Town of Highland Park, Texas

**PUBLIC HEARING
Board of Adjustment**

Town of Highland Park Board of Adjustment

REQUEST: A variance from Section 15-101 to install a perimeter fence, an automated driveway gate, and retaining wall within the 61' front yard setback.

OVERALL PLAN

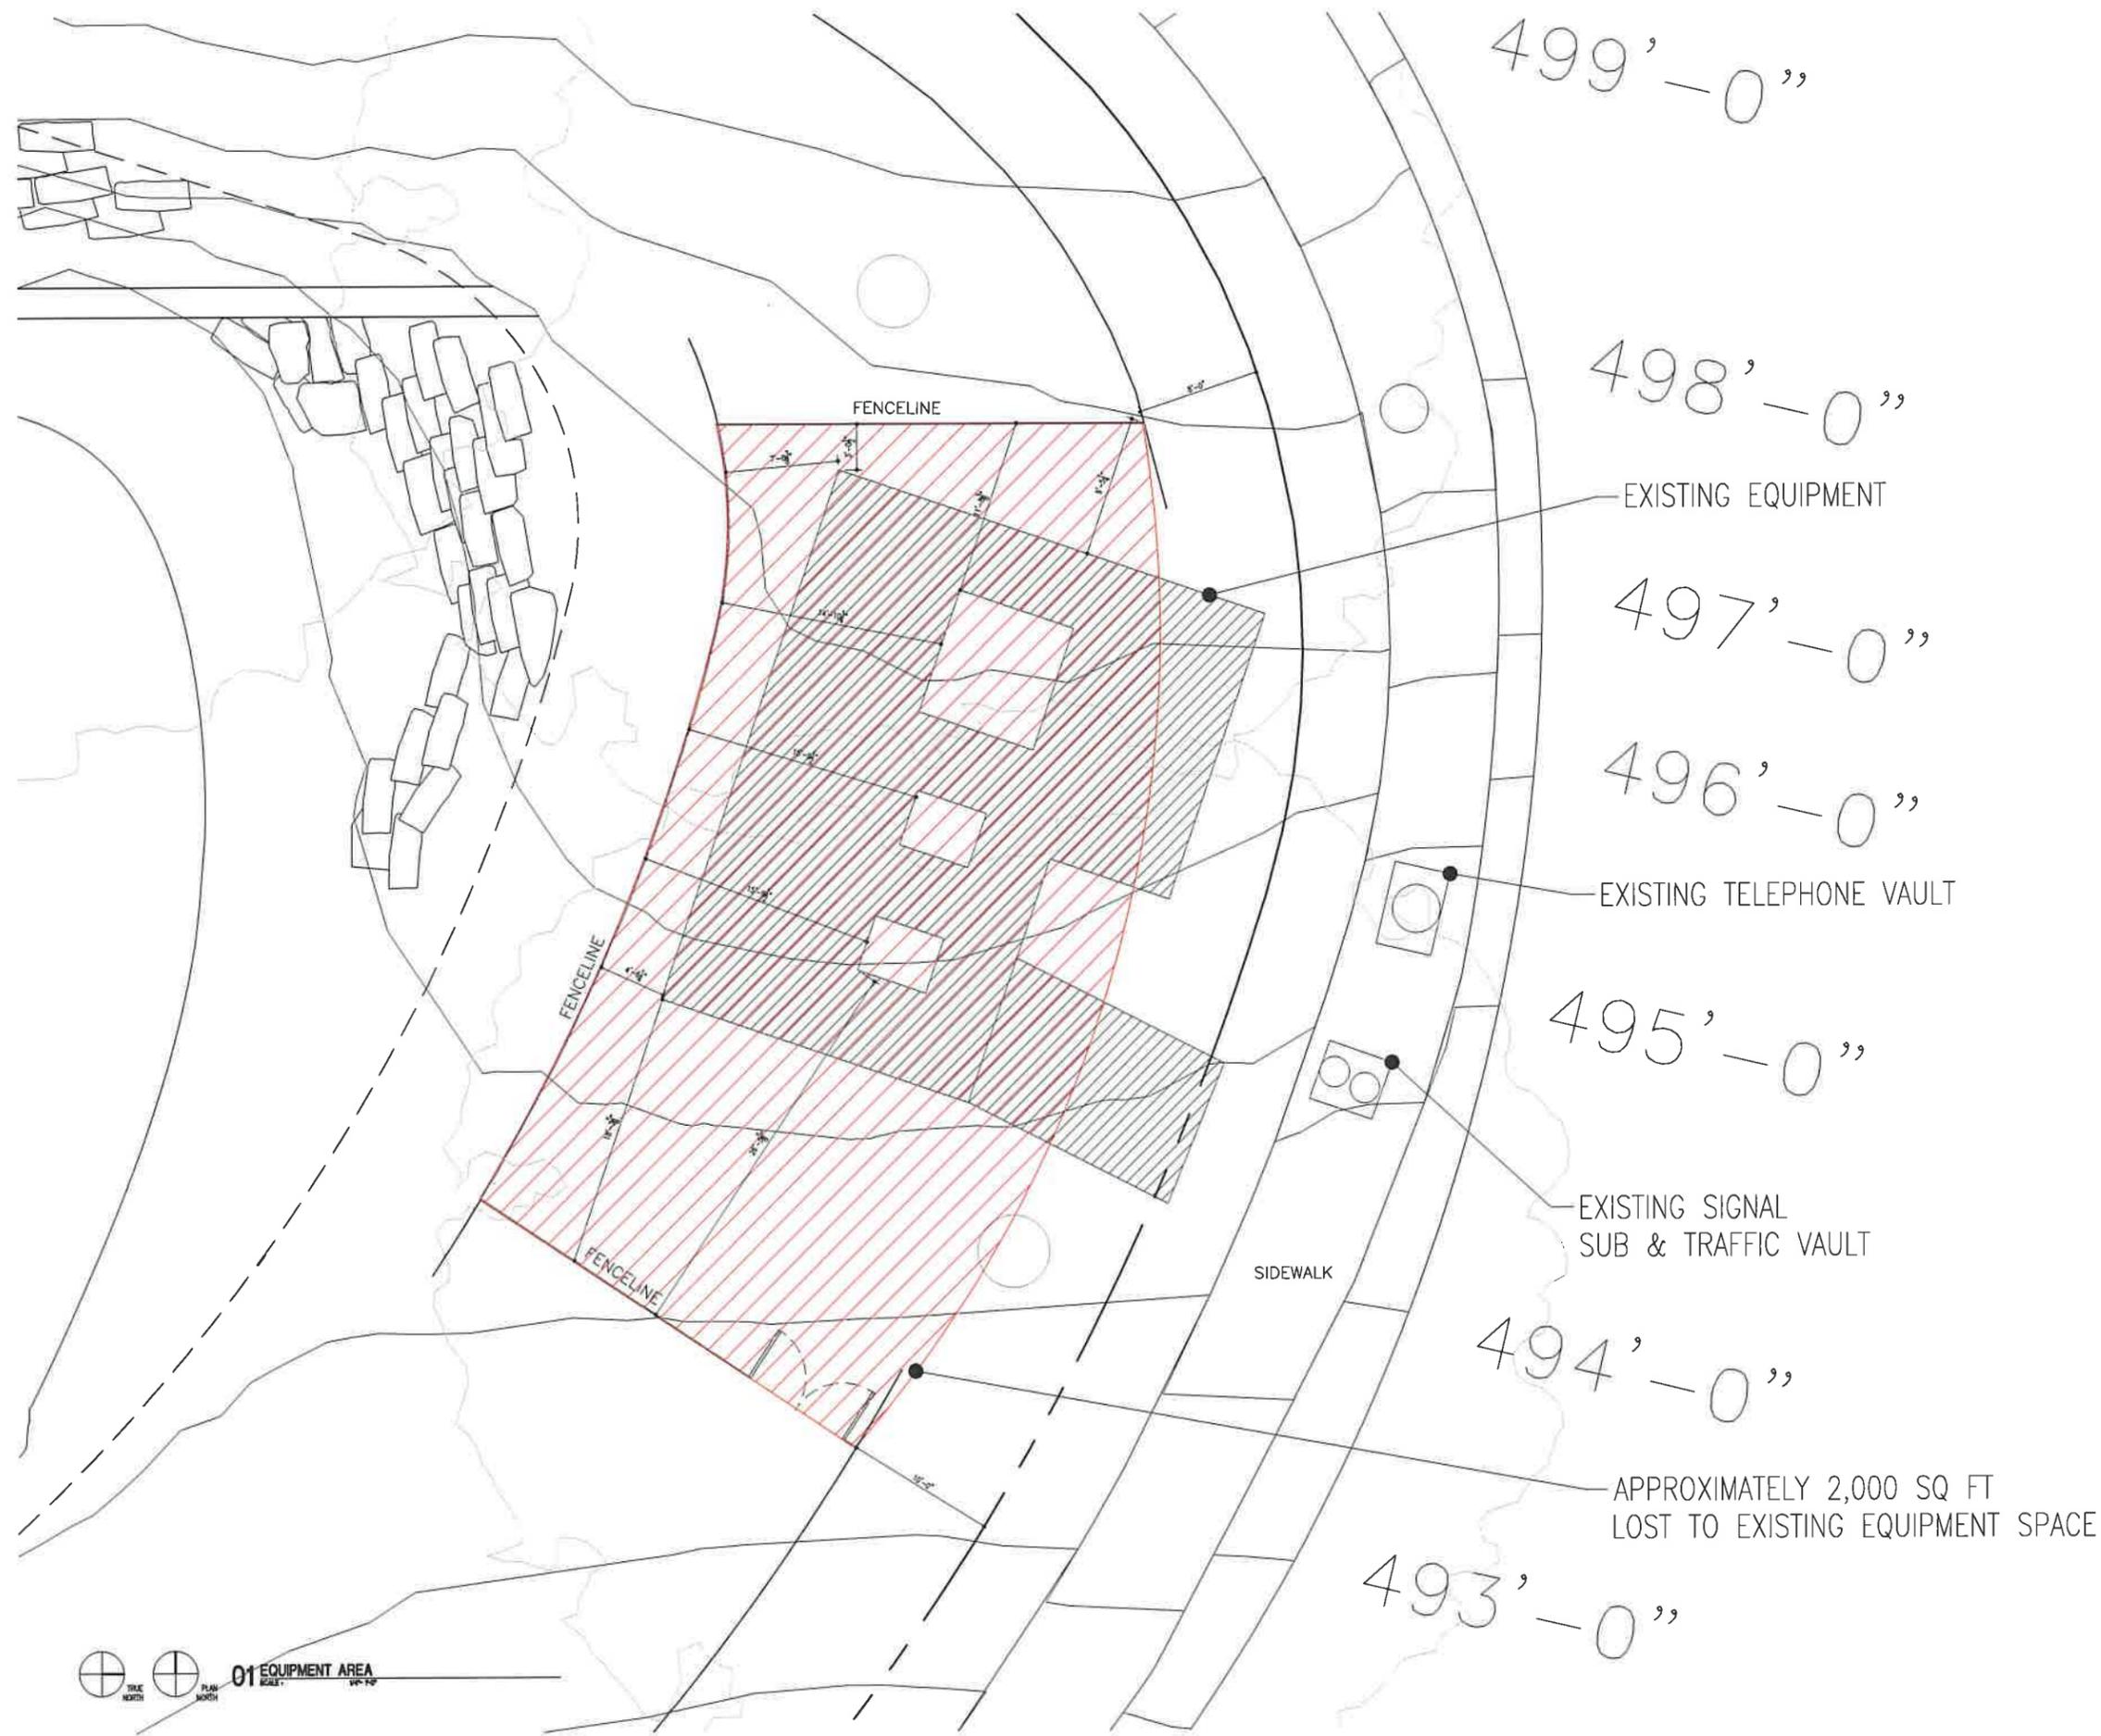
Staff recommends approval per the proposed site plan with the exception of the portion of the proposed wall at the southeast corner of the property that extends across an easement.

1 SITE PLAN
1/8" = 1'-0"

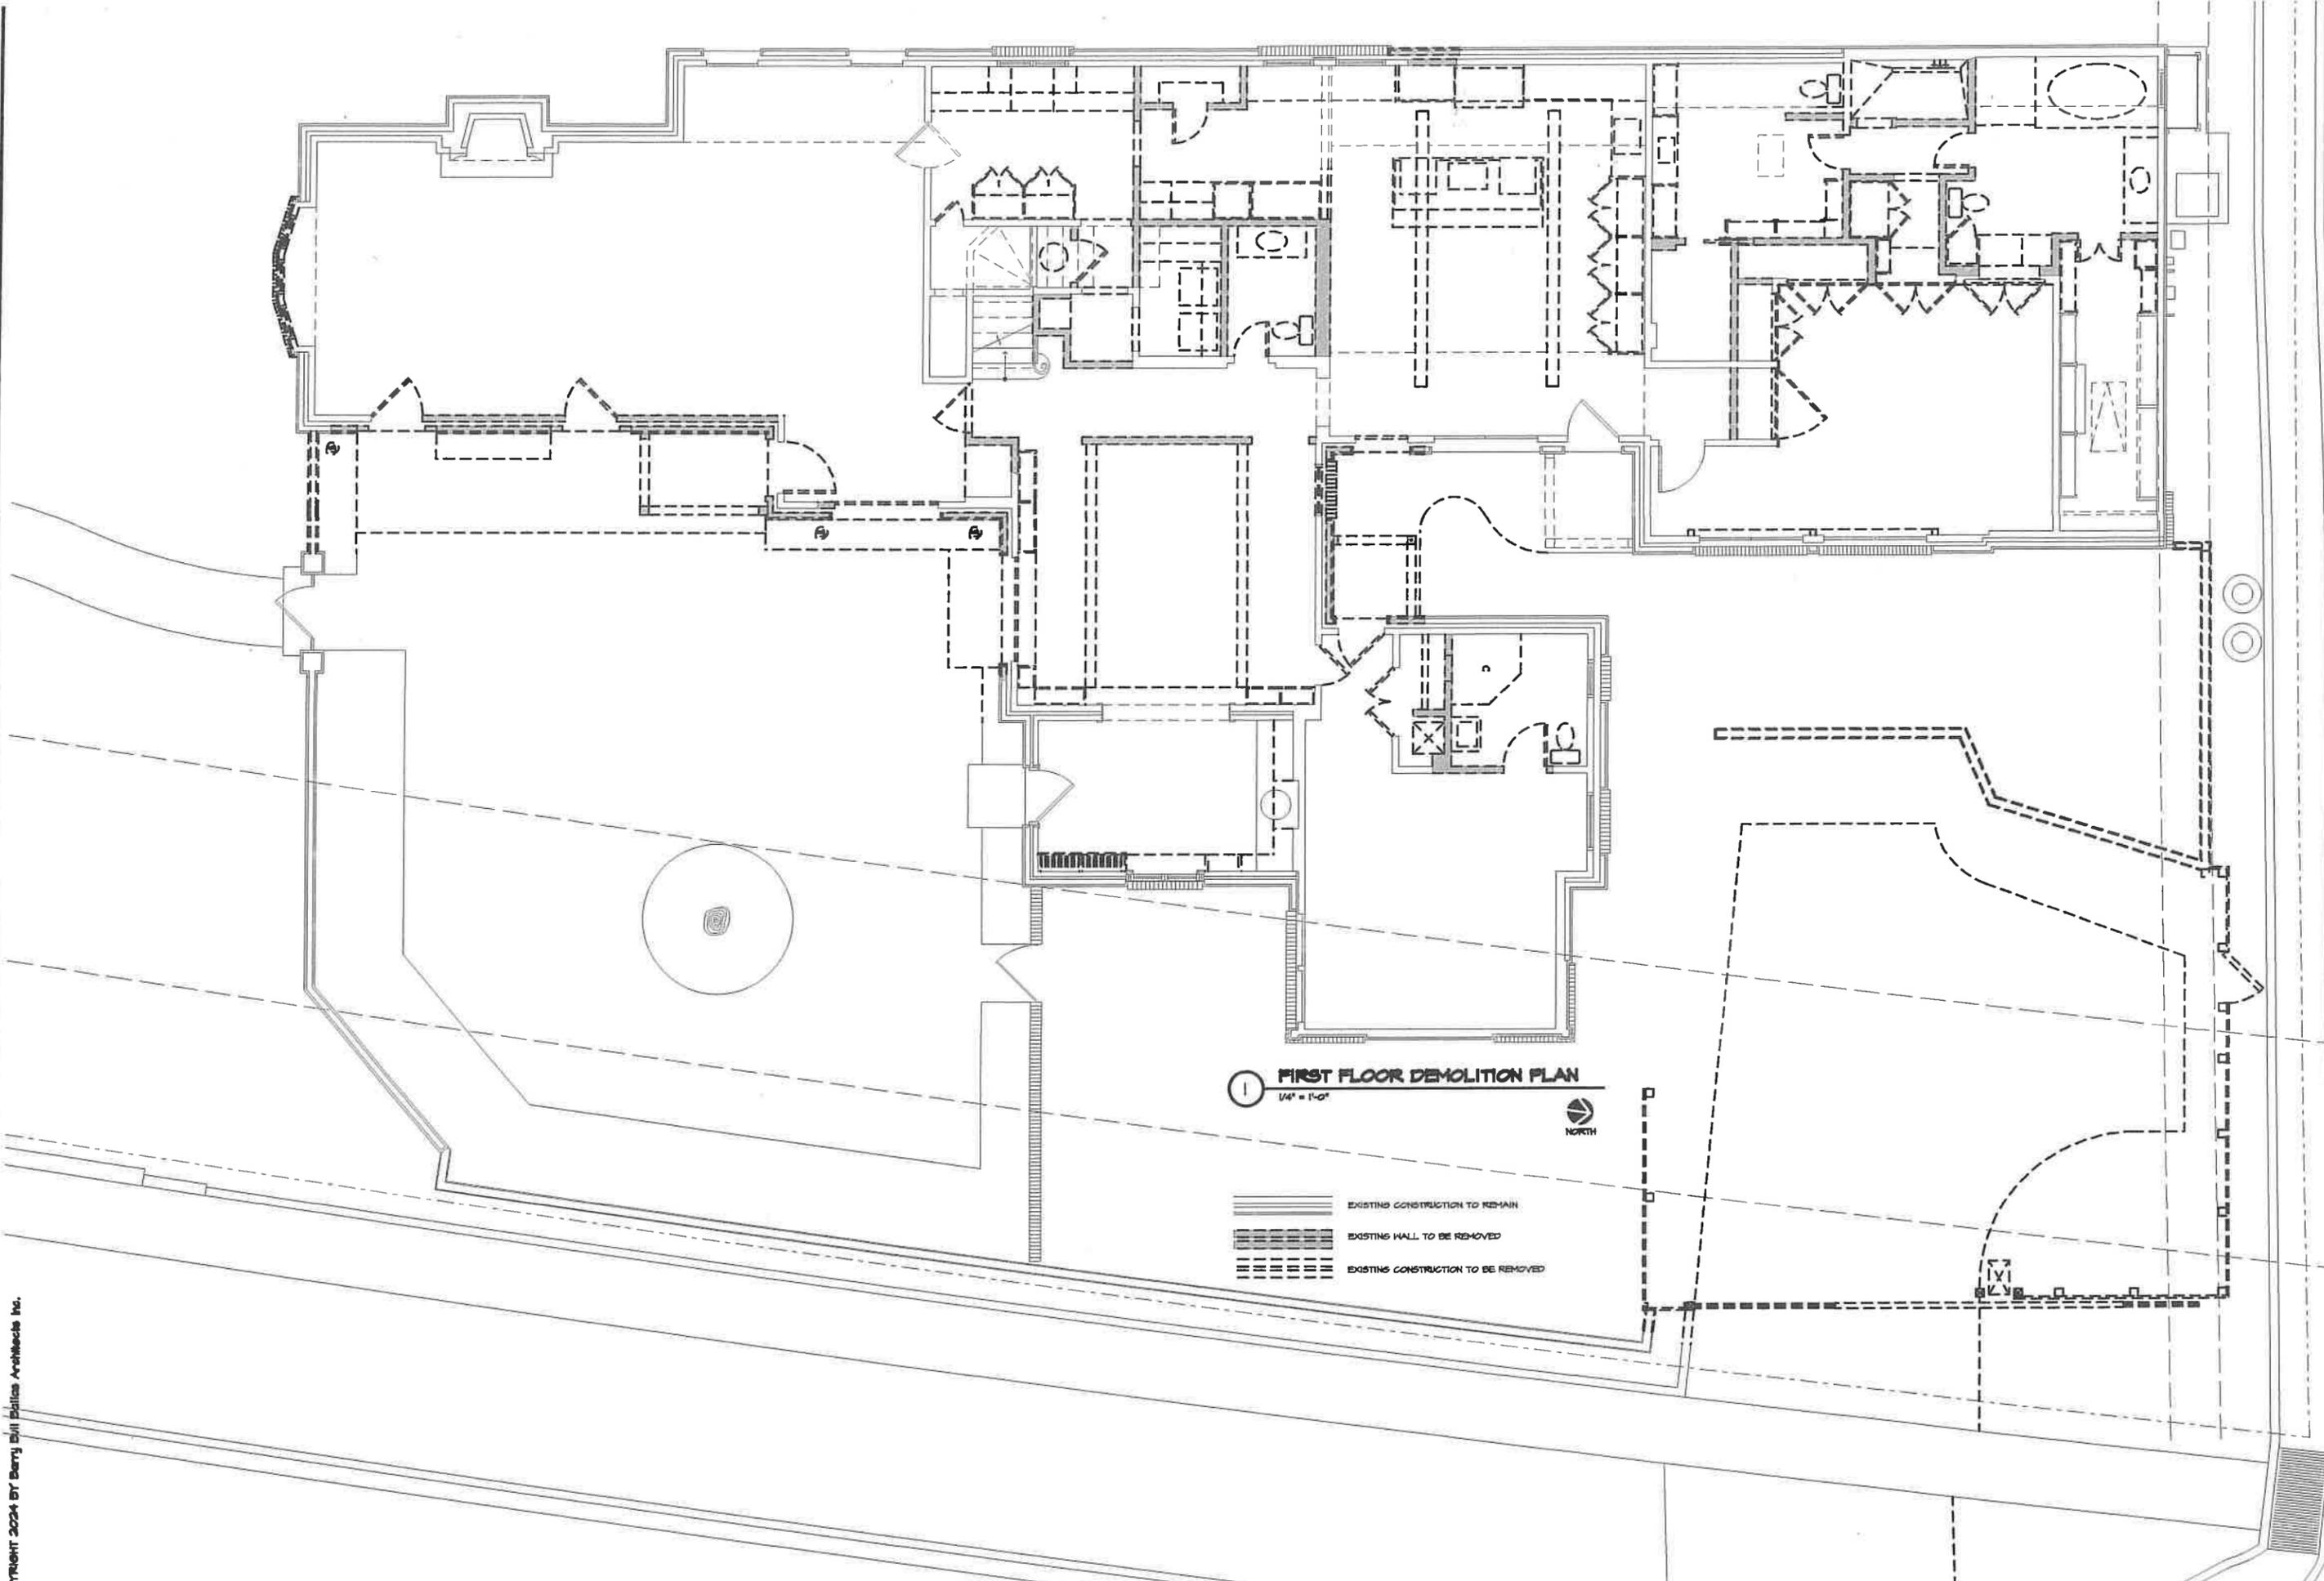
The rear half of the subject property is 6,041 square feet. By ordinance the maximum square footage of lot coverage permitted in the rear half of the lot is 3,020.5 square feet. The proposed garage structure would exceed the maximum square footage of coverage allowed in the rear half of the lot by 231 square feet (3.82%).

Staff recommends approval.
